Project: Public Works Building Transit Addition

We request clarification on the following:

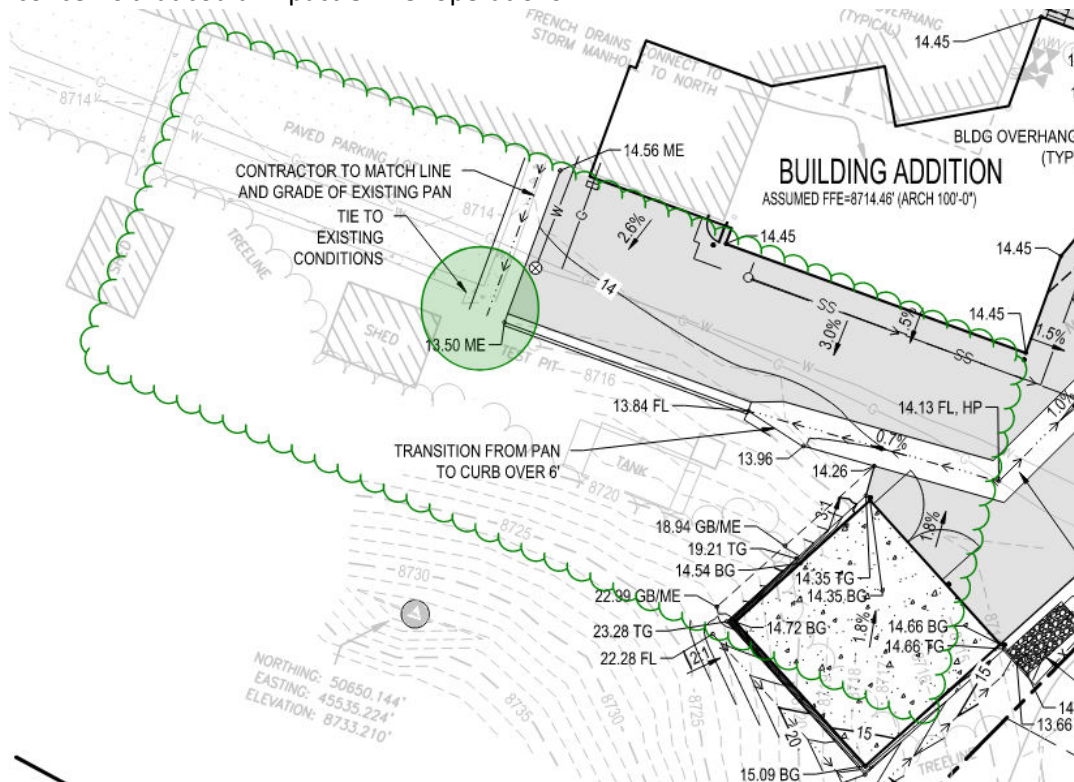
Sheet C1.0 appears to show drainage directed toward the highlighted area. Please clarify where this area is intended to drain and whether the proposed grading will create any pooling or icing concerns that could impact Owner operations.
